Addendum Date: February 10, 2020

CITY OF PENSACOLA, FLORIDA  
ADDENDUM #1

**DEVILLERS STREET REVITALIZATION**

**PHASE 1: FROM MAIN STREET TO GARDEN STREET**

**14.8 UPDATED BRICK DETAIL**

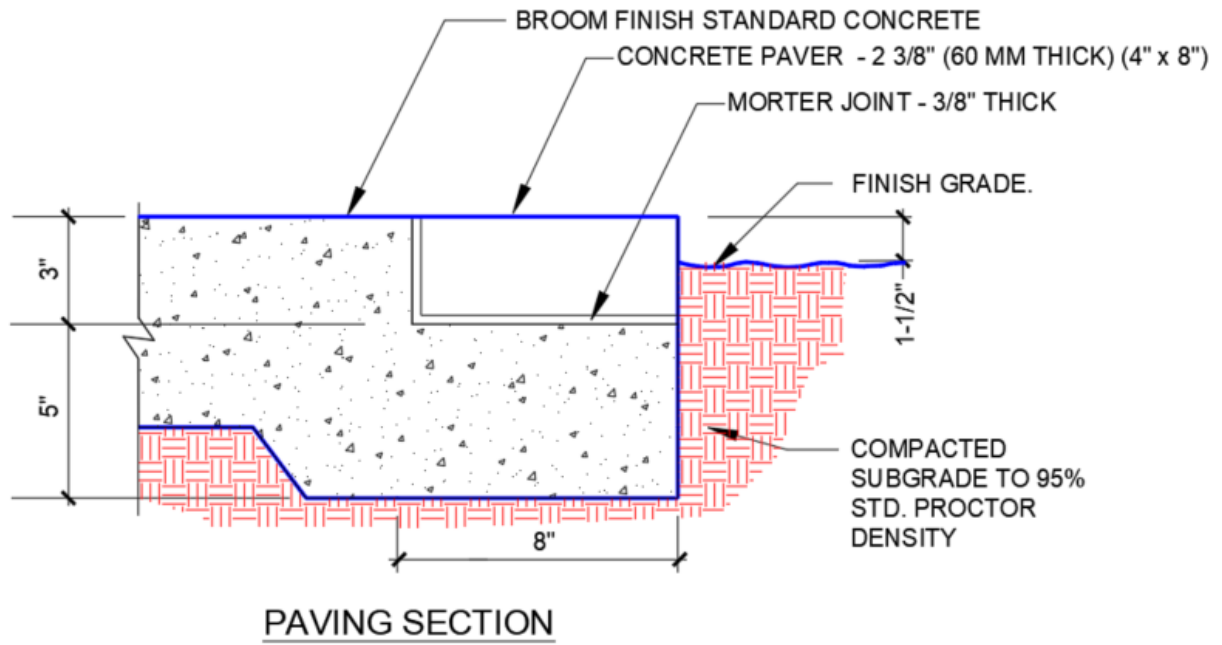
- A. Brick Finish; Butt Joints. Brick shall be laid on the damp, mortar leveling bed to the brick patterns shown in the drawings, using hand tight joints and shall be free from all movement and settlement. After the bricks are laid, broom dry mix into all joints to form a tight surface. Then cover the brick surface with dry mix and tamp again. Sweep any excess sand off the surface. The brick shall then be sprayed with a fine mist of water and maintained in a damp condition for three (3) days. After three (3) days, when mix is dry, broom additional mix into all joints. Clean up excessive mix spread for filling joints. No damaged or chipped brick shall be incorporated in the pavement.
- B. Cut Bricks. Where brick work results in installation of less than full size units, bricks shall be neatly saw-cut to the required dimensions.
